Errata Sheet

Product Family: DL105
Manual Number: D1-USER-M
Revision and Date: 3rd Edition, April 2010

Date: December 17, 2013

Accumulator Timer Example Using Comparative Contacts

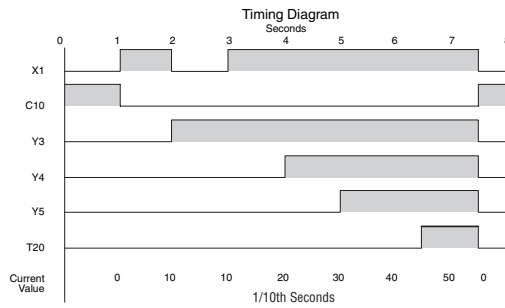
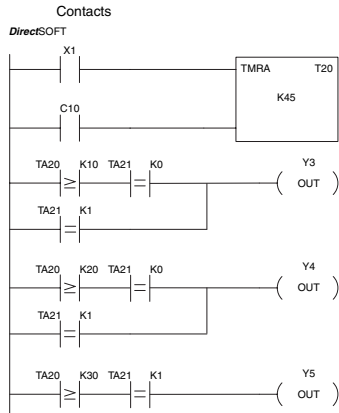
Page 5-31. Accumulating Timer (TMRA) and Accumulating Fast Timer (TMRAF); Accumulating Timer Example Using Comparative Contacts

Replace this entire subsection with the following:

In the following example, a two-input timer is used with a preset of 4.5 seconds. Comparative contacts are used to energized Y3, Y4, and Y5 at one second intervals respectively. The comparative contacts will turn off when the timer is reset.
